From: Anna Tidey
Sent: 05 February 2026 12:17
To: [REDACTED]
Cc: Emily Wade; [REDACTED]
Subject: RE: DM/25/3101 & DM/25/3102 - Discharge of conditions application/ Variation of condition application - Blackbirds, Bramble Hill, Balcombe

'Variation of condition No: 2 relating to DM/25/0873 to allow for minor changes to the overall design which include rear extension parapet roof additional of roof glazing in the side extension and enlarged porch extension with open gable.'

Submitted front door layout detail
Submitted 05.06.2025

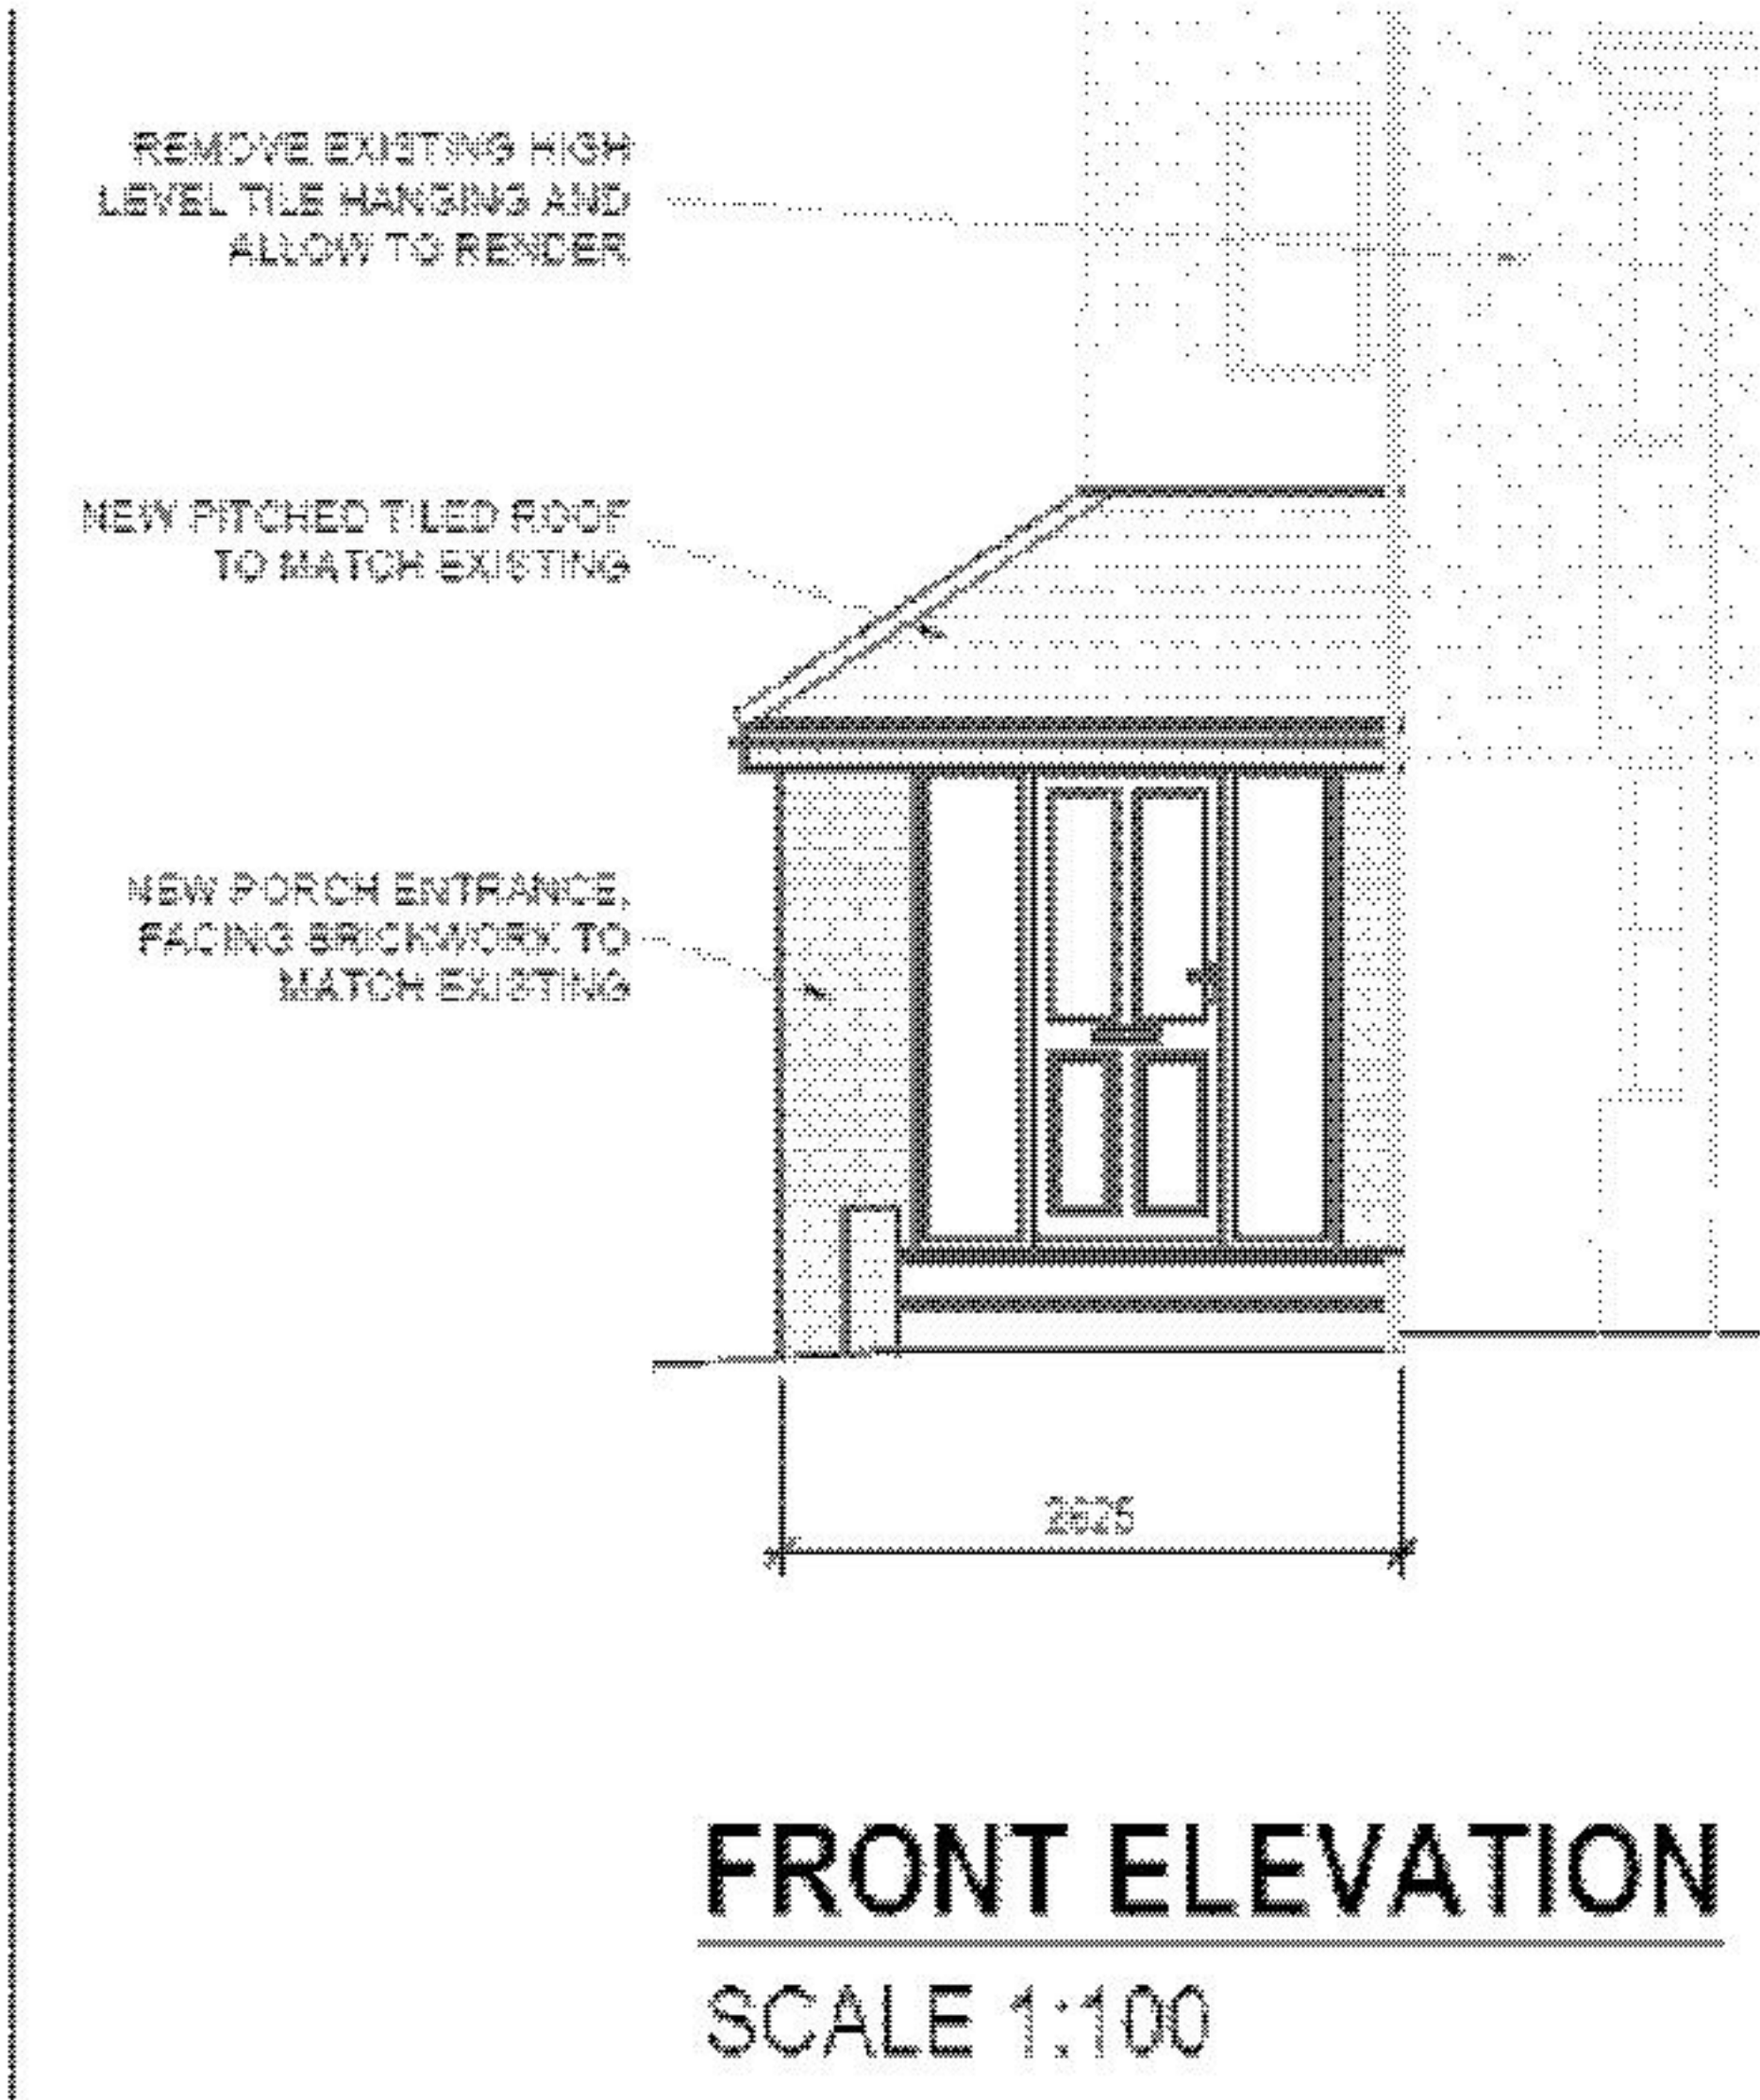
Thank you for your email regarding **DM/25/3102 - Discharge of conditions application**, the content of which I will review with Emily Wade. I note that the submitted front door detail does not correspond to the door design/glazing layout as shown on Proposed Floor and Elevations Plan No1252-02 Rev 05, as approved under DM/25/0873, see copied images below:

The submission of material details for discharge should accord with the Approved Plans showing the design which is to be implemented. A decision will not be made on this application as I have made the application INVALID pending further information on this point.

You may wish to await approval of amended plans ahead of applying for the discharge of the materials condition. Please can you confirm if the front doorway is to be amended to that shown on Proposed Plans & Elevations Drawing No 02, Rev 8, as submitted under DM/25/3101?
